APPEAL SUMMARY

Appeal ID: 21947	Project Address: 4804 SE Woodstock Blvd
Hearing Date: 10/2/19	Appellant Name: Charles Kidwell
Case No.: B-008	Appellant Phone: 5032282840
Appeal Type: Building	Plans Examiner/Inspector: David Bartley
Project Type: commercial	Stories: 5 Occupancy: B, R-2, S-2 Construction Type: I-A, III-B
Building/Business Name: Modera Woodstock Apartments	Fire Sprinklers: Yes - Throughout
Appeal Involves: Erection of a new structure	LUR or Permit Application No.: 19-117964-EA
Plan Submitted Option: pdf [File 1] [File 2] [File 3] [File 4]	Proposed use: Multi-Family Residential

Appeal: Construction Assemblies at Automobile Ramp

MODERA WOODSTOCK

BUILDING SECTION - WEST TO EAST

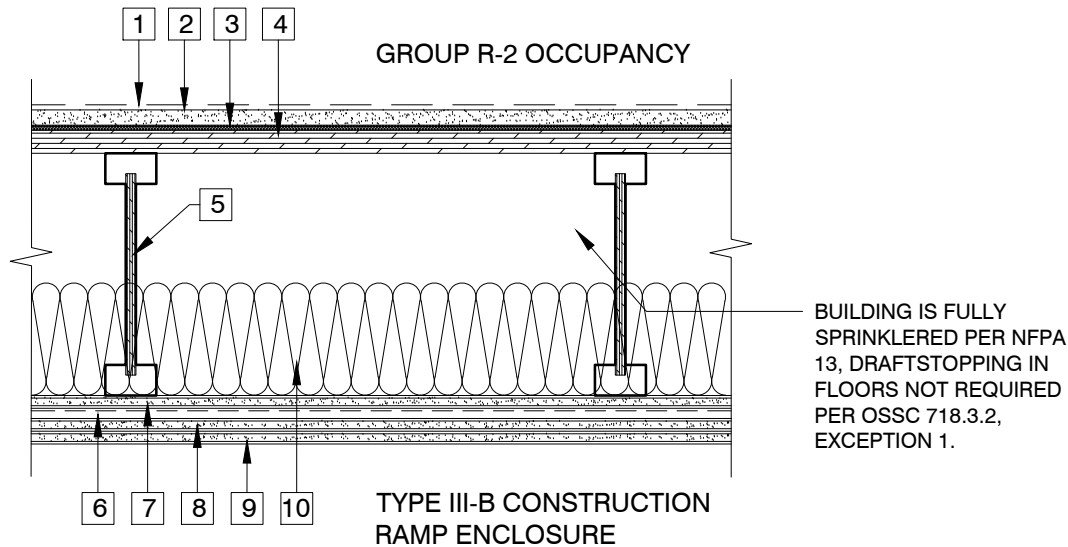
- The walls and floor/ceiling that form the enclosure around the automobile ramp from the street level down to the basement level Parking Garage will be 2-hour rated construction in accordance with code section 510.2 condition #3. **The proposed enclosure surrounding the automobile ramp to the basement level Parking Garage will be code compliant.**
- **The proposed walls and floor/ceiling assemblies forming the enclosure surrounding the automobile ramp will be 2-Hour rated wood framed construction. The assemblies will be protected with non-combustible mineral wool insulation (in lieu of the Fire Retardant Treated wood framing) as explained in the attached Engineering Judgement Report by Code Unlimited.**

See the attached building plans, section and details that illustrate the construction of the proposed enclosure surrounding the automobile ramp.

As indicated in the Engineering Judgement Report by Code Unlimited, the proposed 2-Hour rated wood framed construction surrounding the automobile ramp to the basement level Parking Garage will be a code compliant equivalent means of construction.

Use of 2 hour combustible vertical and horizontal separation between 1A and IIIB construction: Denied. Proposal does not provide equivalent Life Safety protection.

F12

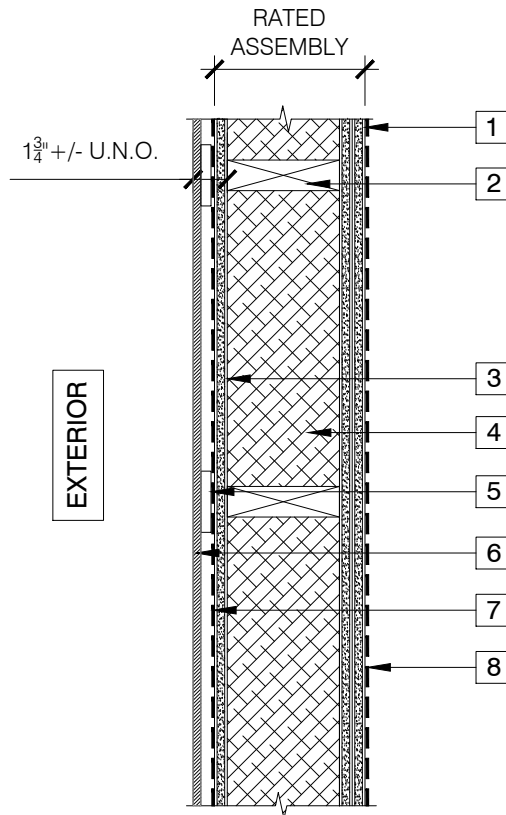
For the required 2-hour fire resistance rating of the ramp lid, the UL-listed assembly will provide equivalent thermal and fire survivability performance to the Type 1 construction of the remainder of the garage structure.

The tested horizontal fire-resistance rated assembly utilizes two (2) layers of 5/8" Type X gypsum board, resilient channel and another layer of 5/8" Type X gypsum board. Gypsum board is considered a non-combustible material and the 3 layers with resilient channel provide a thermal barrier that will prevent the unexposed side of the last layer of gypsum board to remain well below the ignition temperature of the wood TJIs. Since the main concern of this design is the prevention of failure of the floor/roof assembly above the ramp, the ability of the UL listed assembly to maintain the TJI/gypsum interface below 250°F (a primary criteria of the UL listing based on ASTM E-119 testing) means that, for the required 2-hour fire resistance period, the TJIs will not reach the ignition temperature or charring point and will retain the structural integrity for at least the required time.

The gypsum board face of the assembly at the ramp lids between the Type IA and Type IIIB portions of the building construction constitutes and non-combustible separation with a minimum fire resistance rating of 2 hours, based on fire performance of the UL assembly in an ASTM E-119 test and the parameters for pass/fail of that test (maximum 250°F at the unexposed face of the gypsum portion of the assembly).

W10*Appendix A; Figure 1: Exterior Wall*

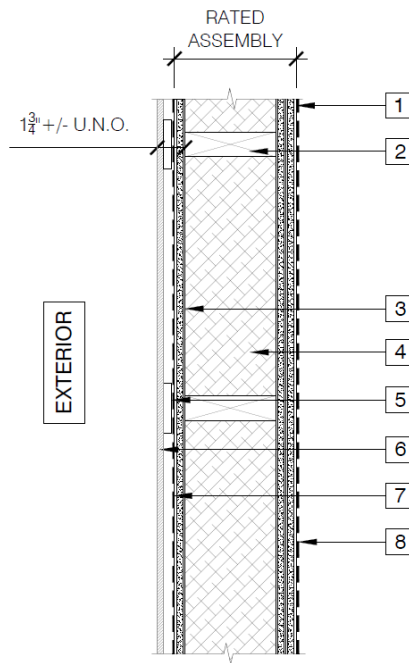
The proposed design is to provide a 2-hour exterior wall assembly that consists of untreated wood stud framing with one or two layers of 5/8" thick type X gypsum board on the interior and one layer of 5/8" type X gypsum sheathing or concrete masonry units on the exterior side of the wall (Non-Symmetric wall) for walls that are further than 10 feet from the property line. Rockwool insulation will be friction fit between studs to fill the entire 6-inch nominal wall cavity. The conclusions of this report are limited to the proposed Wall type shown in Figures 1-4 attached in Appendix A of this white paper.

Mineral wool batt insulation friction fit between the 2x6 studs and filling the entire depth of the wall cavity will provide better protection than FRT wood framing as permitted by OSSC 2303.2 and 603.2. The architect is proposing to use comfort batt insulation by Roxul Company. The batt insulation will be 5.5 inches thick and will be friction fit within the stud cavity. This product is within the parameters of our analysis and the proposed wall assembly will exceed the performance of an FRT wood framed wall assembly. Code does not prohibit the use of better quality products than what is mandated. As this proposed assembly exceeds the base code criteria, it will satisfy the code requirements.
